BRIDGE DESIGN MEMORANDUM

SUBJECT: Design Memorandum 2017-02
Cast-in-Place Deck Haunch Detail, Prestressed Partial-Depth Concrete Deck Panel

DESCRIPTION: **CONCRETE DECK DETAILS -
DECK INTERIOR GIRDER HAUNCH**

Detail 2004 to 2017:

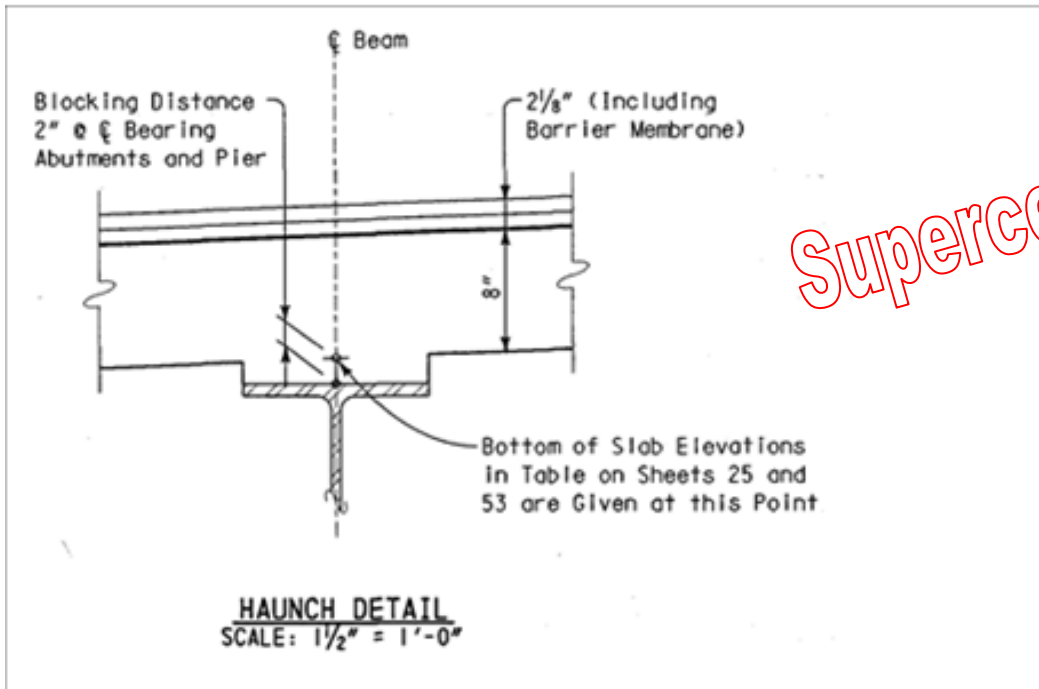
The previous concrete deck interior girder haunch detail extended the haunch 2 ½-in. horizontally from each side of the girder top flange (See enclosed detail). This detail has been shown on contract plans since approximately 2004 to the current date. This portion of the concrete deck is unreinforced and could spall off due to possible future cracking of the haunch.

Superceded

- NHDOT policy for design and construction of cast-in-place concrete deck interior girder haunch detail has been modified. The new concrete deck interior girder haunch detail extends straight up from the edges of the girder flange to the designed haunch depth. The horizontal extensions are eliminated (See enclosed detail). Hangers that are exposed after formwork is removed shall be hot dip galvanized. This new cast-in-place deck interior girder haunch detail shall be used on all new concrete bridge decks.

The objective of this new concrete deck interior girder haunch detail is to eliminate the horizontal extension of the concrete haunch from either side of the girder to prevent any future separation and falling of the unreinforced concrete onto the travel way below. The typical formwork hangers can be used but shall be hot dip galvanized since portions of the hanger will be exposed. The new detail shall be used for all new cast-in-place concrete deck bridge projects.

Detail 1999 to 2004:

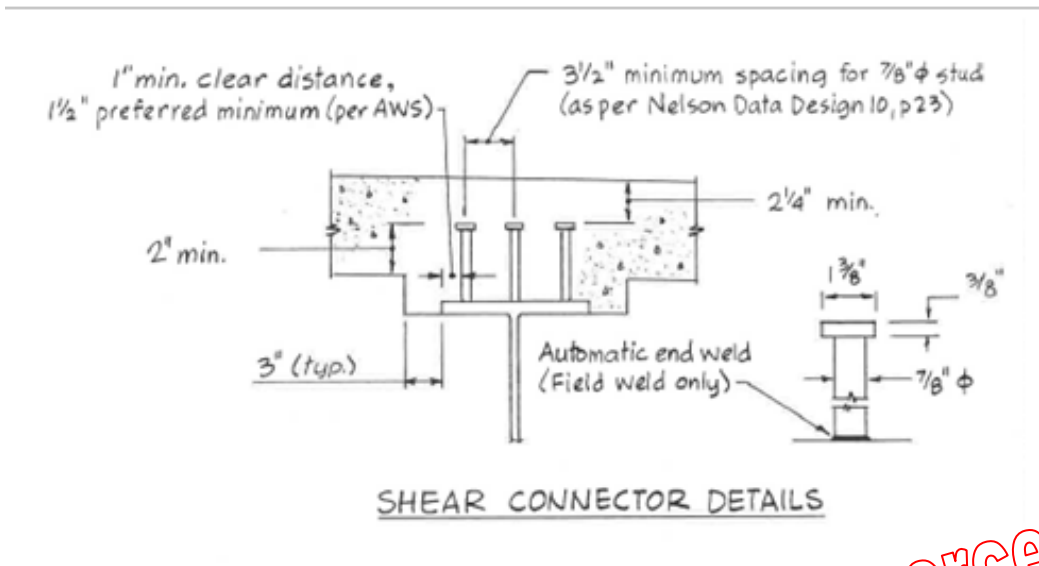
From approximately 1999 to 2004, Bridge Design used a deck interior girder haunch detail that extended straight up from the girder flange edges (See enclosed detail). This detail made it difficult for Contractors to form the deck. The typical interior deck hangers could not be used since the metal end portions of the hanger would be exposed and rust. Other alternate hangers would be very costly. Therefore, the horizontal extension of 2 ½-in. was implemented so the typical interior deck hangers could be used.

Superceded

Detail prior to 1999:

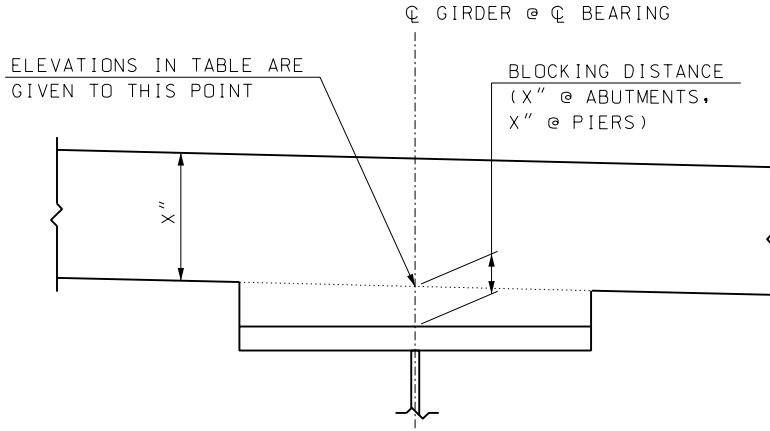
An older deck girder detail that was used prior to 1999 extended the haunch 3-in. horizontally from each side of the girder bottom of top flange (See enclosed detail). Cracking of the unreinforced concrete haunch has loosened portions of the concrete due to forces generated by corrosion on the vertical edges of the flanges. This loosened concrete has separated and fallen onto the travel way below.

Superceded
